CUSTOMER TECHNICAL MEMO # 230

Subject: Torrens Door

TORRENS DOOR

AD40
MID RAIL SPIGOT
NO VISIBLE SURFACES

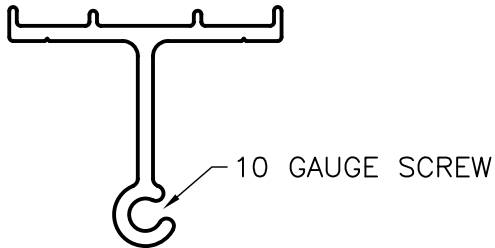
We have addressed the midrail fixings for AD50 & AD51 with the introduction of AD40 spigot. Currently stocked in 4.5m lengths as it is used cut to two different sizes depending on whether it is used in AD50 or AD51.

AD1025
FLOOR TRACK

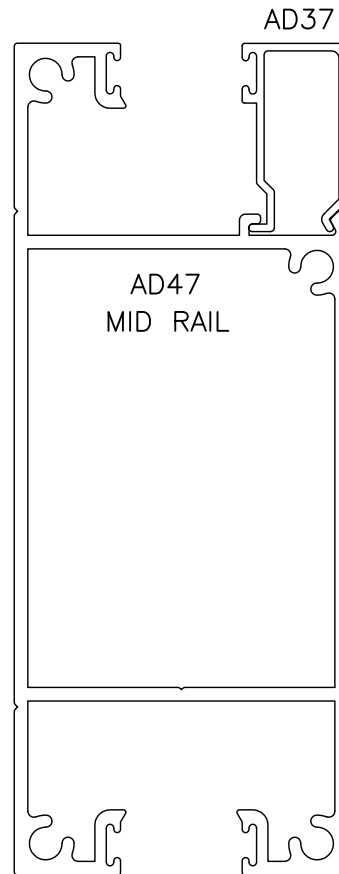
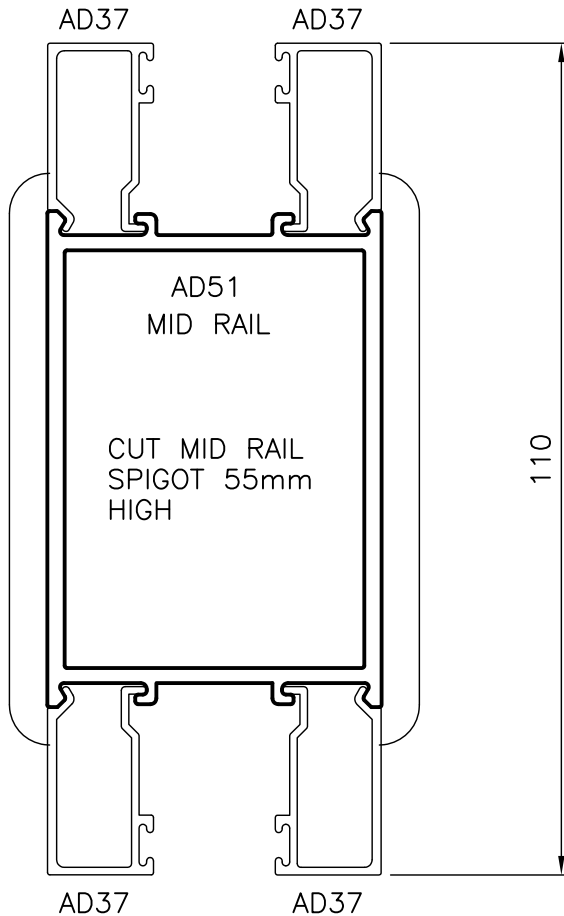
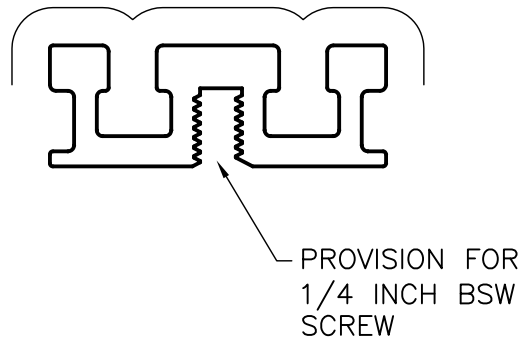
Replaces E10435 FLOOR TRACK

Rollers to suit are 1378013 AD1058 SHOPFRONT DOOR ROLLERS (Doric DR137)
